PRODUCT CHANGE NOTIFICATION

#PCN-DCT-WKK1-12

Description of Change:

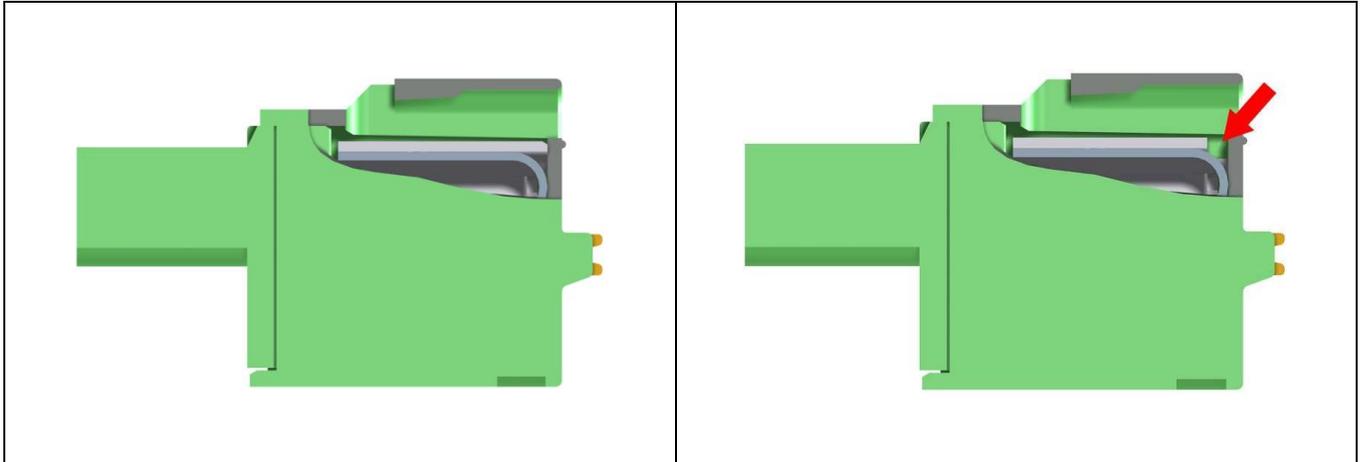
Due to our continuous improvement process, the metal parts will now have the same geometry in the test-plug area as the FKC plugs (cut out). The quality characteristics for the test-plug and the technical data do not change. During the conversion period both versions will be delivered depending on the inventory.
